# Technical Bulletin

## TB 0310 – Additional symbology to GIS and AutoCAD for HV switches

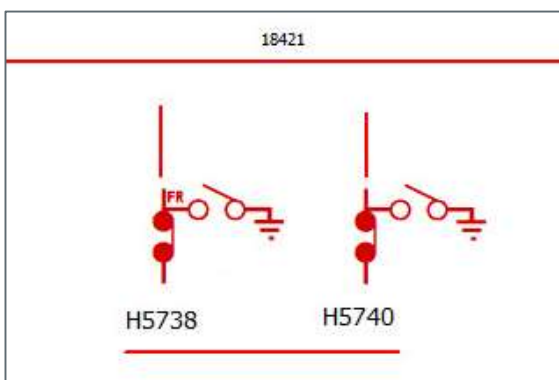
The current process for capturing this data on UG substations is with a hand drawn SC arrow, with no attribute data.

Further, no such attribute or symbology exists on the substation detail window.

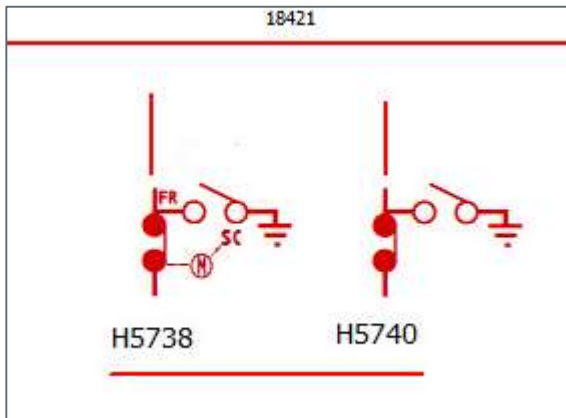
In addition to the creation of these two attributes, it is proposed that HV switches will have the option to add two graphical components; the Motorized RMU and SC symbols.

The detail window for substations will also have labels placed on each switch, where applicable.

HV LBS example in GIS and CAD. Note that the GIS symbology uses existing SC enabled symbol.

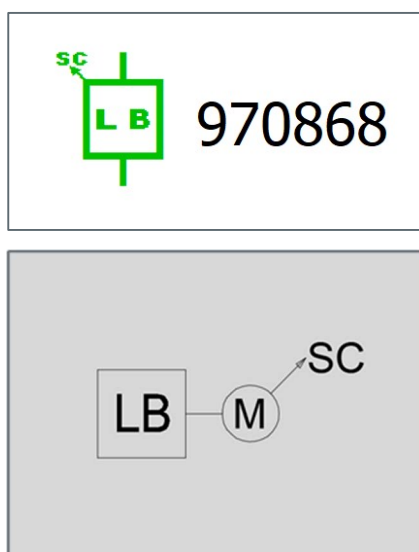
Drawing 294854 – Drawing Specification Standard Drawing Symbols will be updated to include new symbology, allowing for designers to capture this information on project drawings as well as integration with the CAD to GIS process.

Typical examples of common switchgear configurations for ground Substations in CAD:

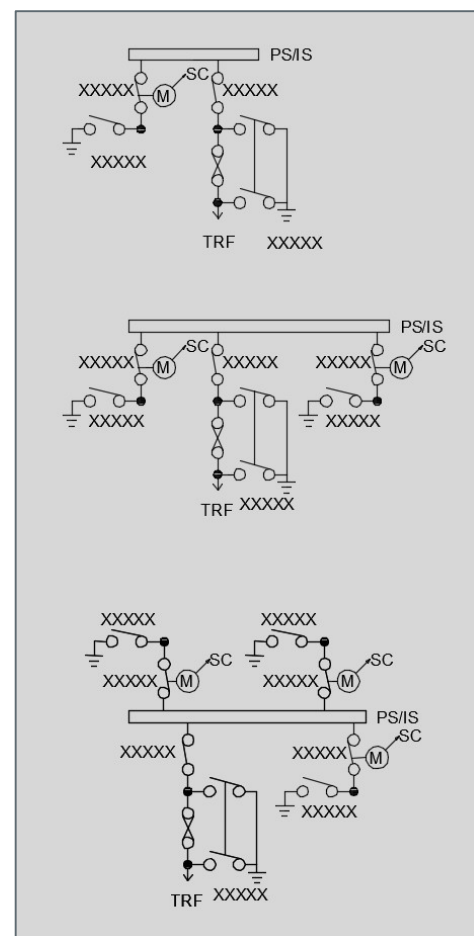
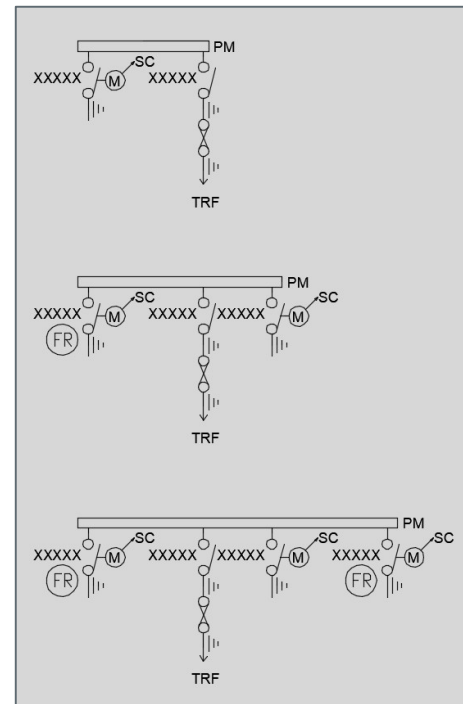
All current HV switches will have both attributes defaulted to 'No' with both symbology options available for placement.
